Customer Name:		Gallien-Krueger		Current Rev #:		A1		New ECO Rev #:		A2	
Model:		Backline 250, 600, 115 Combo,		Distribute To:				Page:		1 Of: 2	
Assembly Description:		and 210 Combo		Originator:		Enrique Hernandez					
Assembly Numbers:		206-0181-A		Approved by:				Effective Date:		2/15/2005	
Effective				Document Update				Date		Initials	
<input checked="" type="checkbox"/>	All in Process	<input checked="" type="checkbox"/>	Next Buy	<input type="checkbox"/>	Artwork						
<input type="checkbox"/>	All in Service	<input checked="" type="checkbox"/>	Next Production Run	<input type="checkbox"/>	Assembly Dwg.						
<input checked="" type="checkbox"/>	All in Stock	<input type="checkbox"/>		<input type="checkbox"/>	Board Artwork						
Beginning Serial Number:				<input checked="" type="checkbox"/>	BOM						Noli
Reason For Change				<input type="checkbox"/>	Control Form						
Pre-Amp revoiced to sound more like the 400RB-IV.				<input checked="" type="checkbox"/>	Costing						TC

TITLE: BACKLINE 115 PREAMP
DRAWING NO: 406-0181-A
REV: A2

Customer Name:		Gallien-Krueger		Current Rev #:	A2	New ECO Rev #:	A3		
Model:		Backline 250, 600, 115 Combo, and 210 Combo		Distribute To:		Page:	1	Of:	2

BACKLINE 115 PREAMP
DRAWING NO: 406-0181-A6
PART NO: 206-0181-A6
COMPANY: GALLIEN-KRUEGER
RELEASER: 8/16

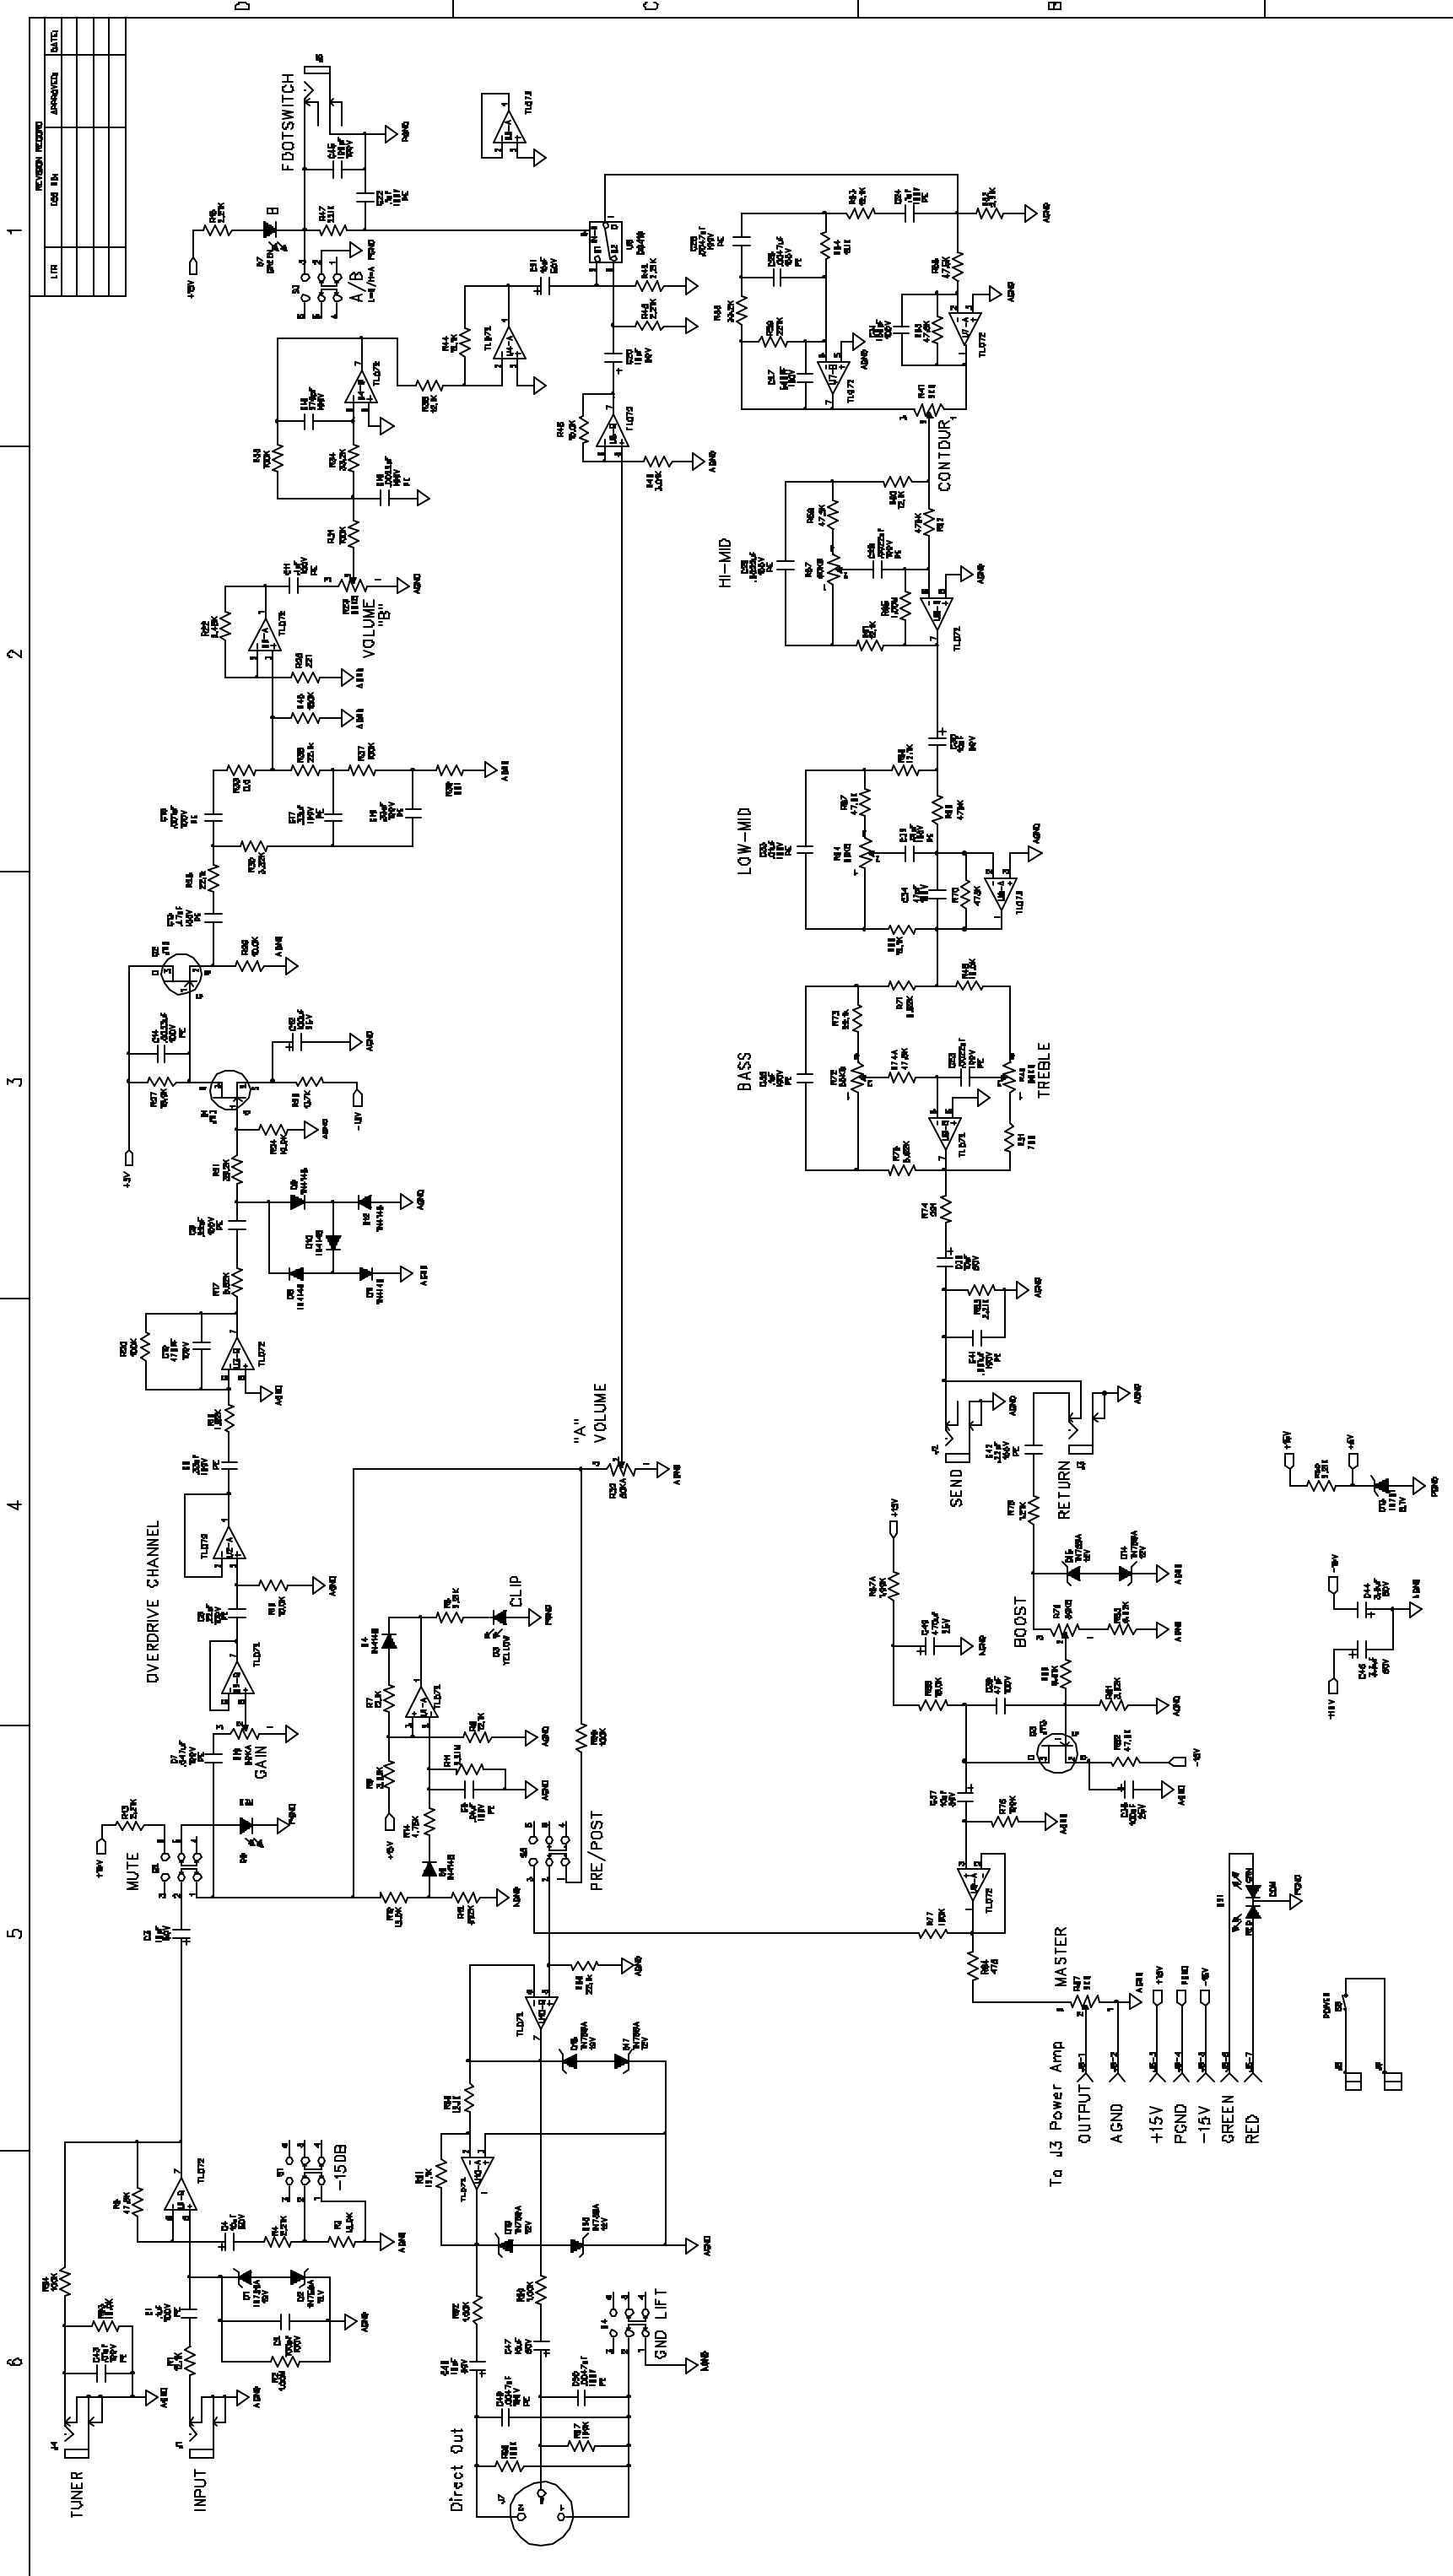
NOTES A6:
1. MOVE R80 TO TOP OF R32.
